**FINAL ENVIRONMENTAL IMPACT STATEMENT (EIS)
KALIA TOWER, HILTON HAWAIIAN VILLAGE
HILTON HAWAIIAN JOINT VENTURE
TAX MAP KEYS: 2-6-9: POR 9 AND 13**

We are notifying you that the above Final EIS document is **ACCEPTED** pursuant to Chapter 343, HRS, and Title 11, Administrative Rules, Department of Health, Chapter 200, Environmental Impact Statement Rules.

**Kalia Tower
Final
Environmental Impact Statement**

Figure 4.8
 Anticipated Noise Levels
 During Pile-Driving Operations
 Hilton Hawaiian Village

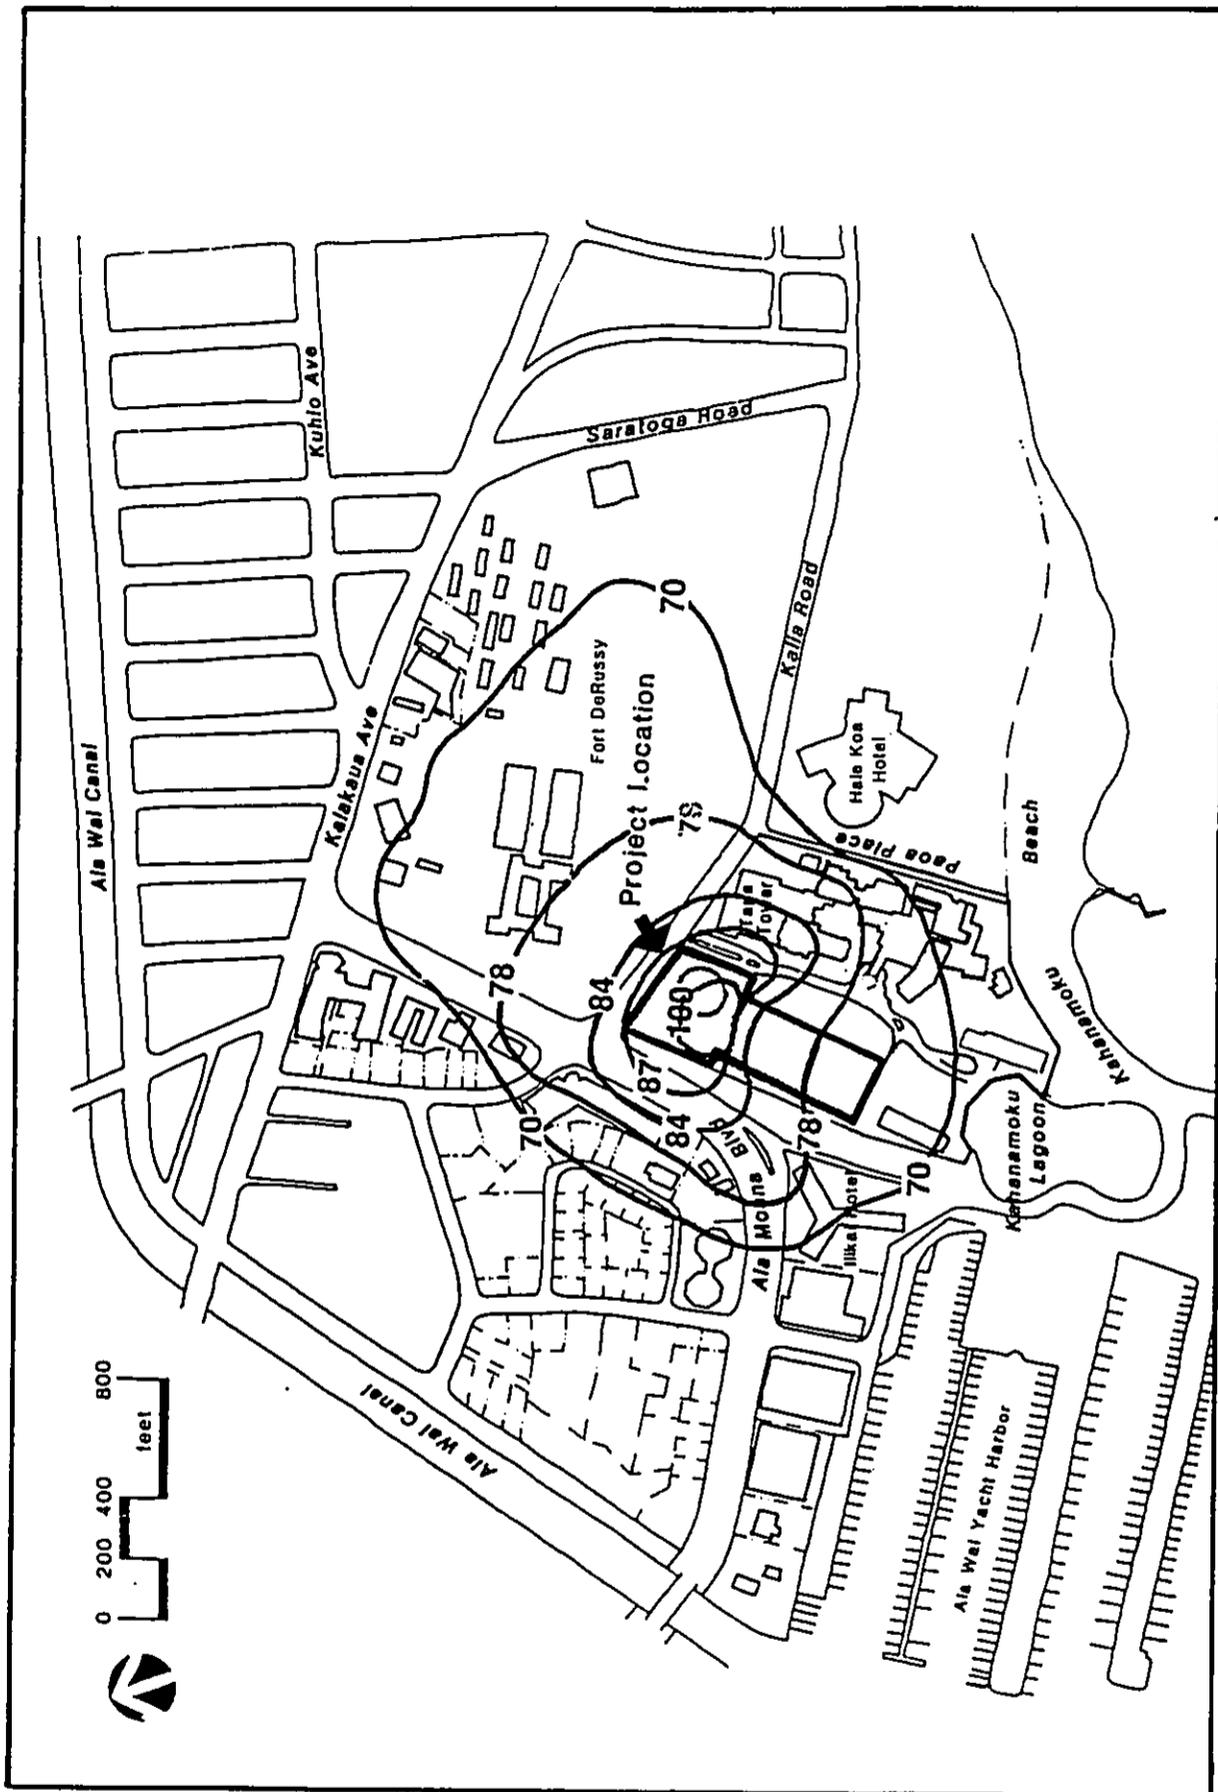
The DEIS treats noise from construction activities quite seriously. Figure 4.8 makes it clear that noise levels in excess of 100 dB could occur on and immediately around the equipment during pile-driving and that exterior noise levels from this source could exceed 80 dB for short periods at the closest point on neighboring properties. Noise from other construction activities will be considerably lower, but Section 14.4 of the DEIS makes it clear that construction noise is likely to be annoying and even disruptive. Section 14.7 discusses ways that the impacts could be reduced, but notes that the possibilities are limited and that they would not radically reduce noise. Construction activities are limited and short-term in nature, and must conform to Department of Health regulations regarding noise emissions.

1. Existing view from Hobron / Ala Moana Blvd.

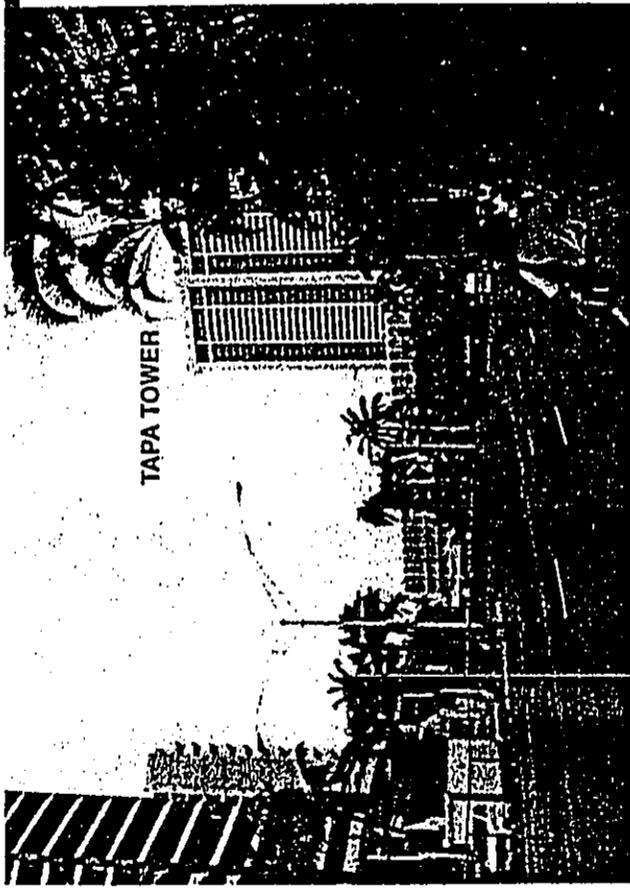
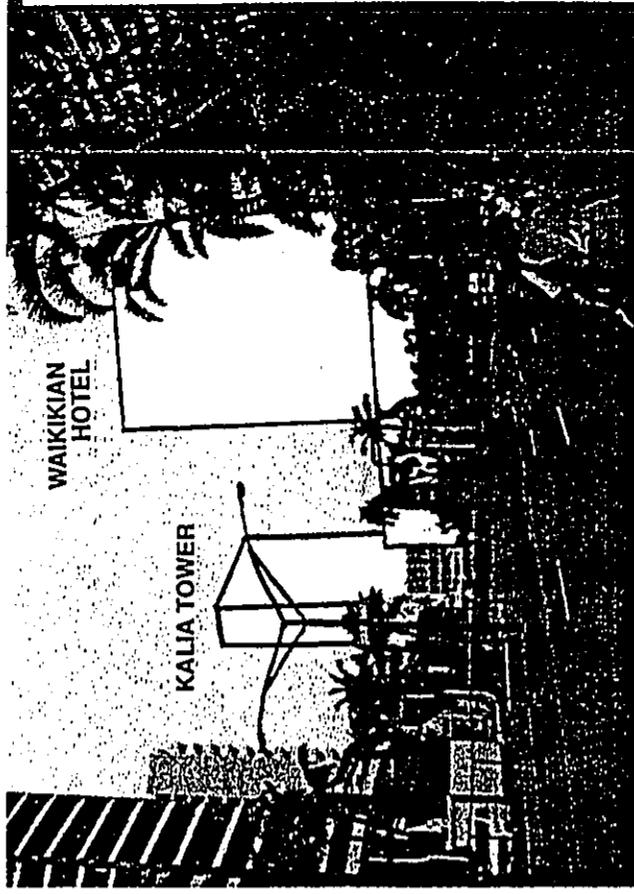
We must disagree with your assessment of the view plane analysis performed within the DEIS. In particular, we feel that the proposed Waikikian Hotel will have a much greater impact upon the views within the Waikiki Gateway than you state. The size, shape, and positioning upon the lot of the Waikikian Hotel will present a visual focal point, which, although superimposed to some extent against the Tapa Tower, will nevertheless, create a far more imposing image that can be seen from Ala Moana Boulevard. The attached photographs show how the proposed buildings would appear from the vantage point you suggested.
